**Arizona Solar Working Group Comments
On the Draft EIS for the Restoration Design Energy Project
May 16, 2012**

The Arizona Solar Working Group (ASWG) is pleased to offer these comments in response to the Draft Environmental Impact Statement (DEIS) for the Restoration Design Energy Project (RDEP). ASWG is a working group comprised of representatives for the solar energy industry, the electricity utility sector, and the environmental community dedicated to promoting areas in Arizona suitable for environmentally responsible solar development. It is our hope that the diversity of this group and the consensus-based comments we offer will provide a valuable perspective to BLM's Arizona Office.

Figure 1: West parcel of BLM land that may be suitable for renewable energy development.

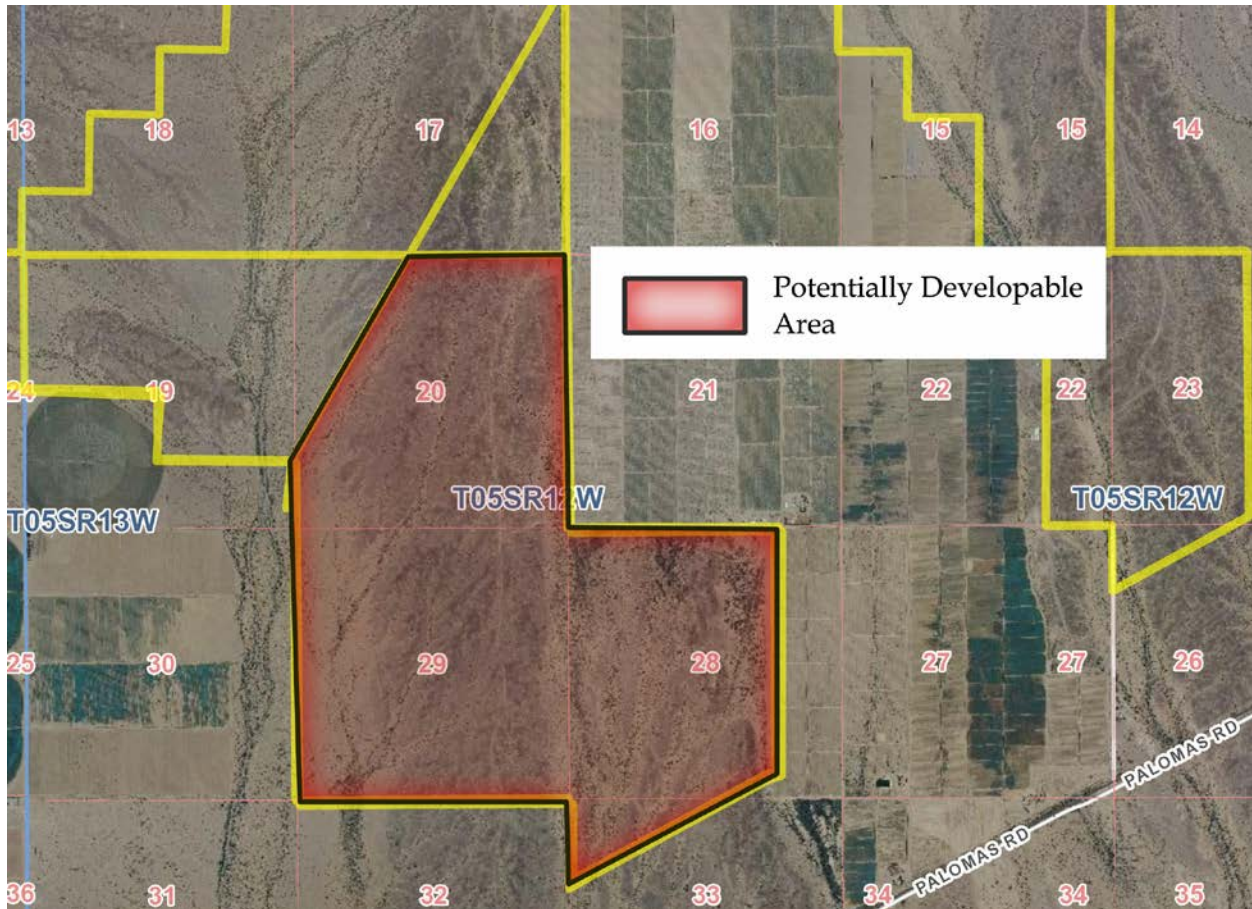
- **Parcel of approximately 2,000 acres west of the southern portion of the White Wing Ranch solar development (Figure 1):** This parcel has seen severe impacts from users, making it suitable for large-scale development with few impacts on issues of environmental importance. The BLM should address public access to BLM lands north of this parcel if development is proposed here.

Figure 2: Land on the eastern edge of the proposed Agua Caliente SEZ that may be suitable for solar development. Mitigations measures would be necessary to minimize impacts to major riparian areas that traverse the site.

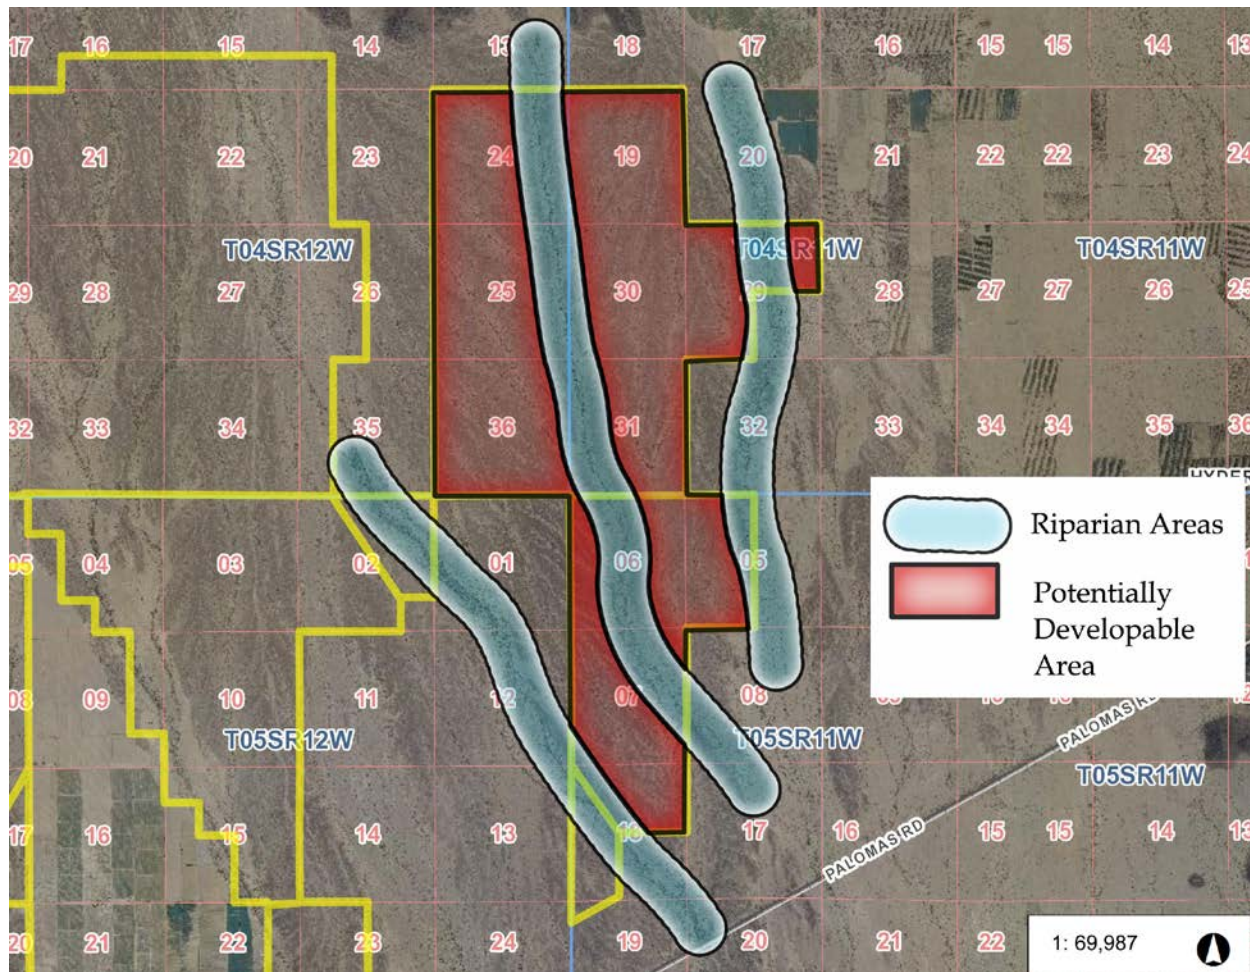
- **Parcel of approximately 8,000 acres on the east side of the proposed SEZ (Figure 2):** This site has potential for large-scale development as it avoids two of the three major issues that exist on other areas of the proposed Agua Caliente SEZ including Citizen Proposed Wilderness (CPW) lands and major conflicts with the hunting community. While there are ecologically sensitive areas including xeroriparian zones within this parcel, it is of sufficient size and scale to both accommodate renewable energy development and likely mitigation factors including the following:

- **Washes:** The Desert washes including the large Baragan Wash should be preserved within a sizable corridor that can accommodate wildlife passage and protect existing ecological resources.

- **Access:** Legally created roads and trails within and around this parcel that are not damaging to natural and cultural resources should be accommodated either in their current locations or in appropriate places to ensure continued access to these and proximate lands.

- **Wildlife:** Wildlife connectivity in both the east-west and north-south directions should be preserved under any development scenario to limit the negative effects of fragmentation of the Palomas Plain Wildlife Habitat Area.
